NUCLEAR FUEL SERVICES, INC.
a subsidiary of The Babcock & Wilcox Company

21G-11-0145
GOV-01-55-04
ACF-11-0233

Subject: Revised Chapters 2, 7, 10, and 11 for Renewal of SNM License 124

SNM-124, Chapter 2, Revision 1

Figure 2-1: Functional Organization Chart

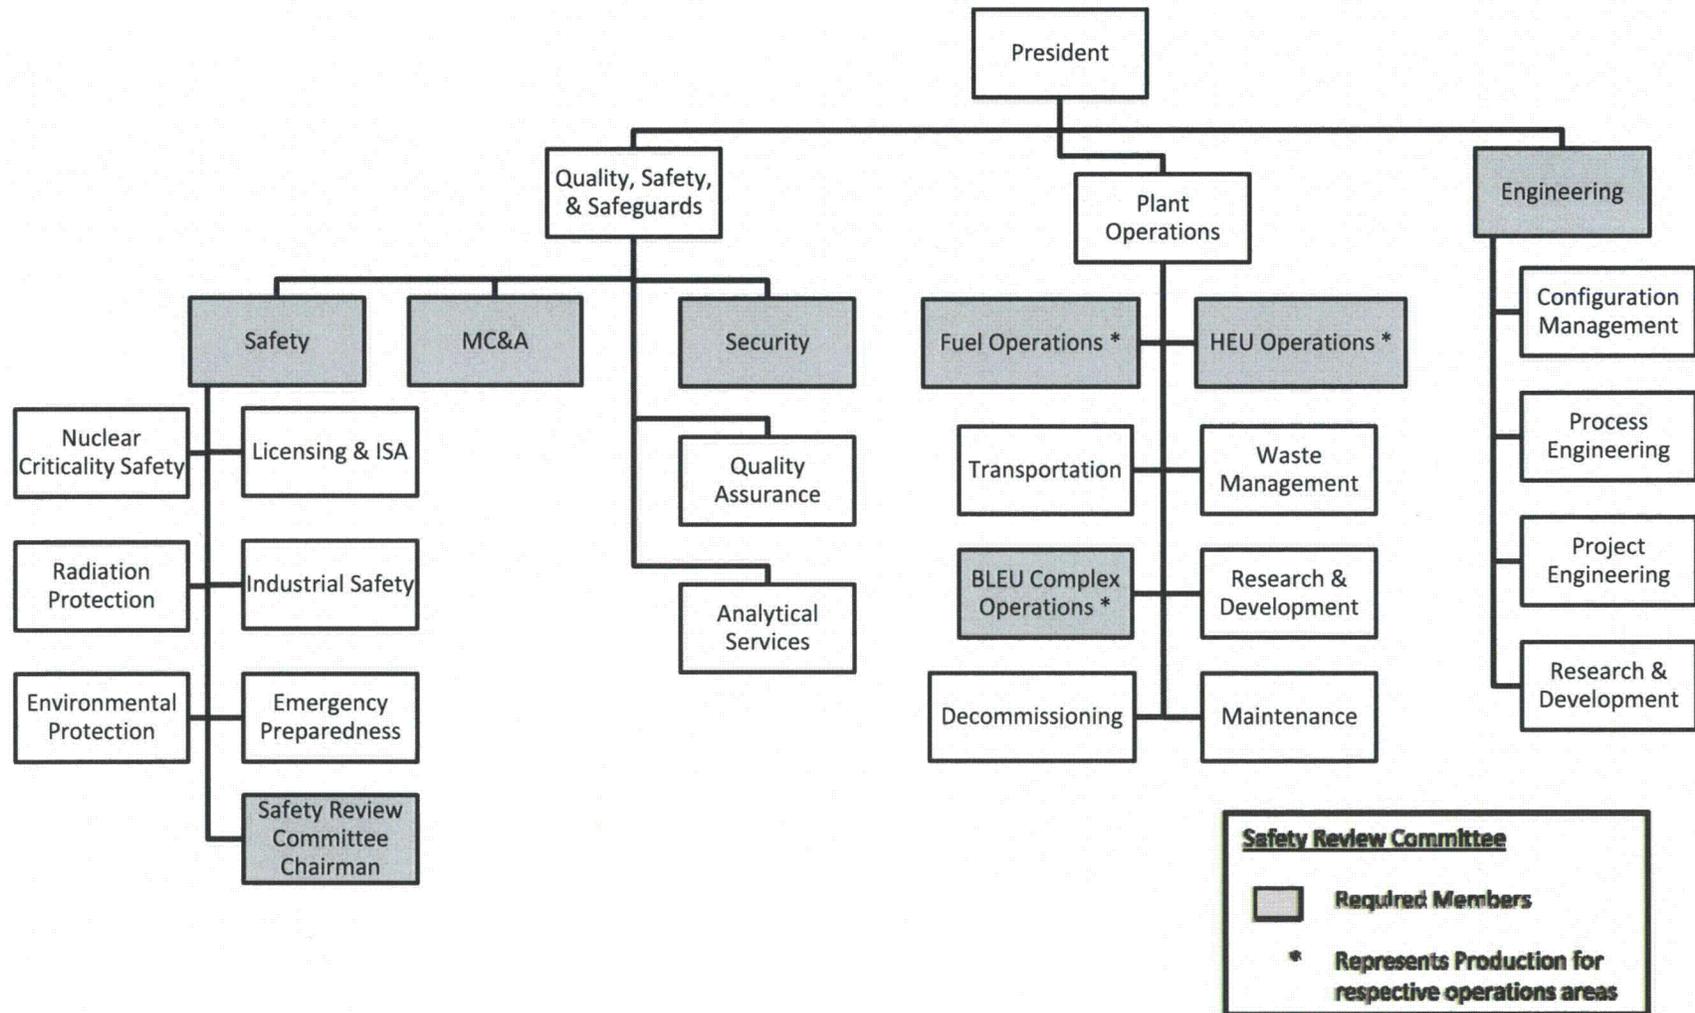
- Figure 2-1 – updated in response to RAI 2.1.
